File: 39T-13501/Z-8139
Planner: Nancy McKee

TO:	CHAIR AND MEMBERS PLANNING AND ENVIRONMENT COMMITTEE
FROM:	GEORGE KOTSIFAS, P.ENG. MANAGING DIRECTOR, DEVELOPMENT & COMPLIANCE SERVICES AND CHIEF BUILDING OFFICIAL
SUBJECT:	APPLICATION BY: WASTELL DEVELOPMENTS INC. 655 TENNENT AVENUE PUBLIC PARTICIPATION MEETING ON APRIL 23, 2013 NOT BEFORE 4:30 PM

The purpose and effect of the proposal is to develop a subdivision with 44 single detached lots, served by one new local street.

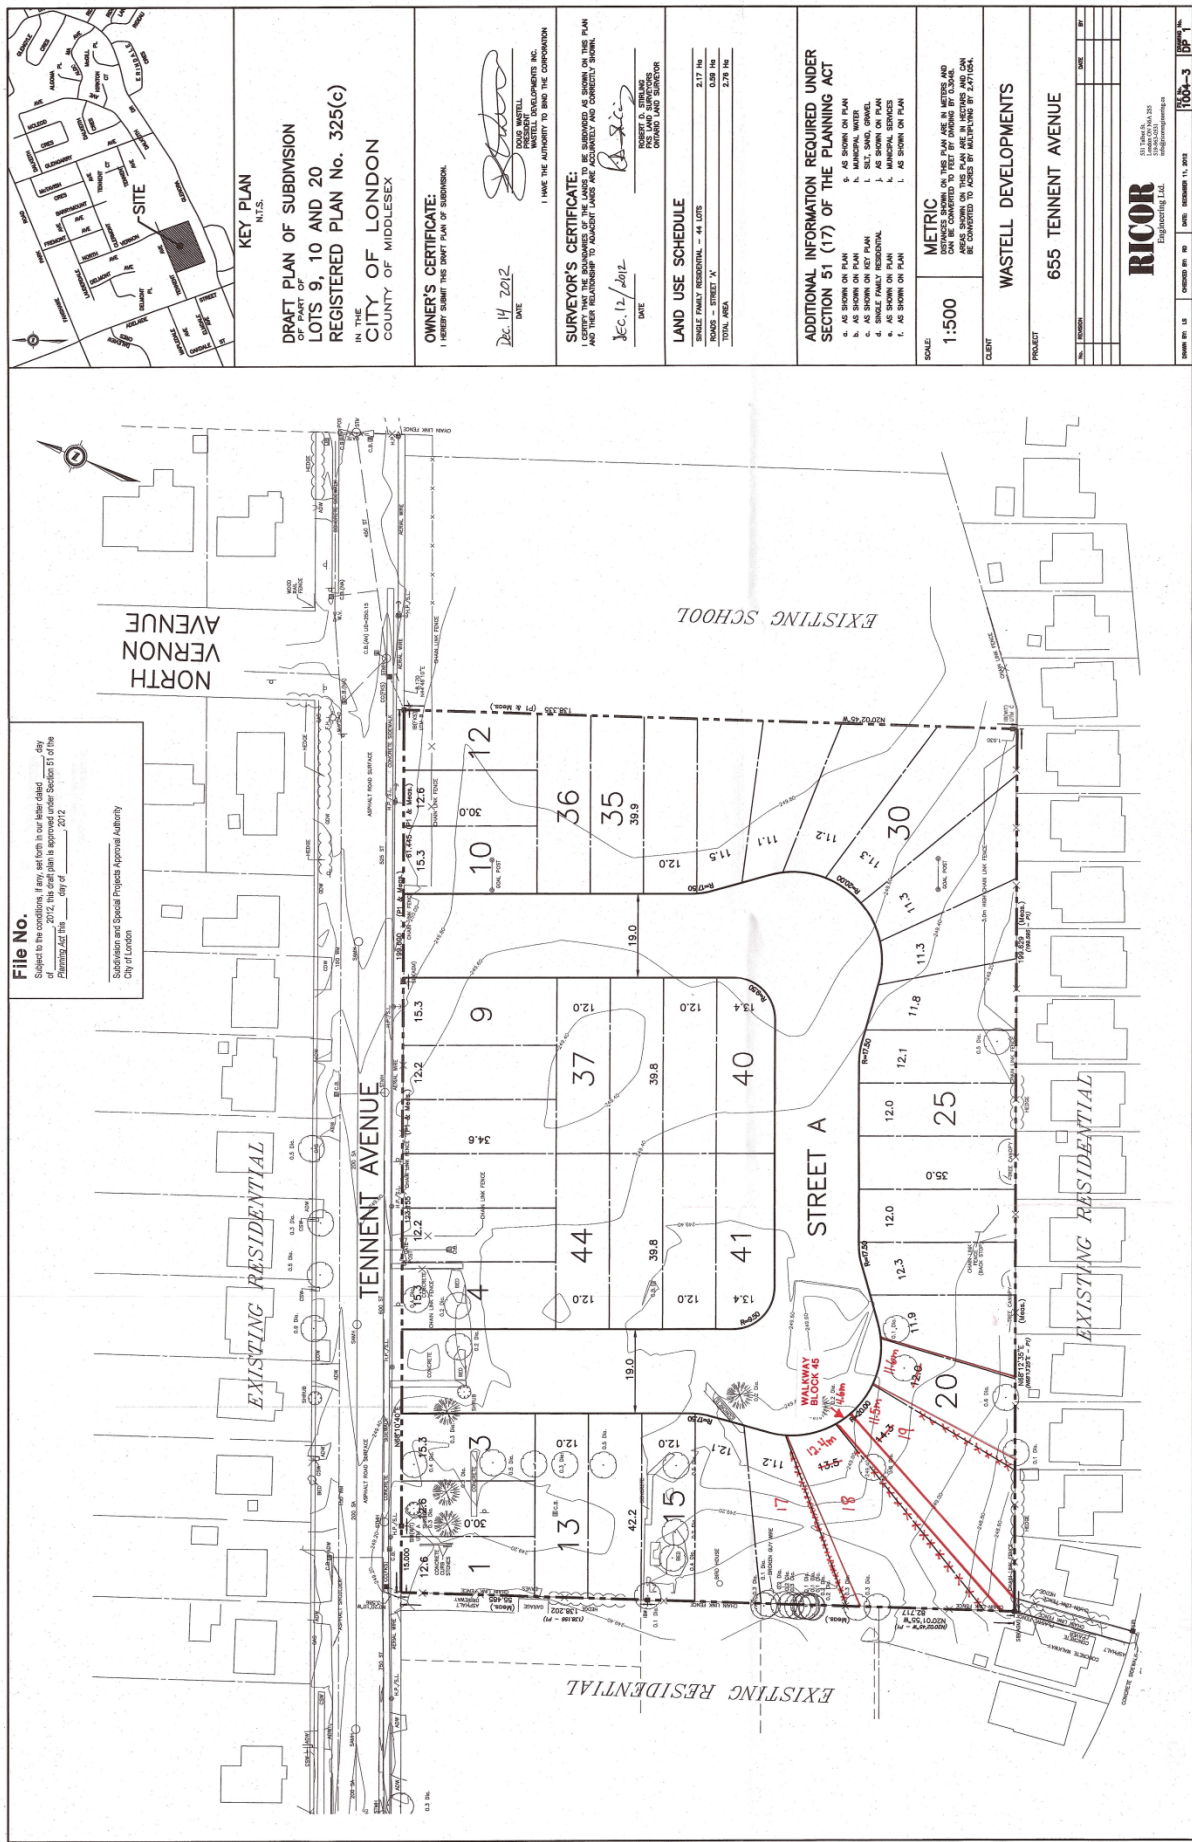
The only redline change proposed is the addition of the walkway to connect to the existing walkway out to Glenora Drive. The walkway will be 4.6 m in width and will necessitate having a bend in it. From a Crime Prevention through Environmental Design (CPTED) perspective, this is not ideal. However, with the inclusion of lighting and “rounding” of the bend this will improve the sight lines and make this walkway safer and accessible to all residents.

Currently there is a foot path that runs from Glenora to the SW corner of the old Norhdale lot. The concept plan shows that path blocked off at the back of lot 19. I would like to see that path extended through to the proposed street. This would allow easier flow of pedestrian traffic for Lucas SS, bus stops, the Adelaide/Tennent plaza, etc.

Staff Response: Conditions to support the Engineering comments have been added to the draft plan. The walkway block has been redlined into the draft plan.
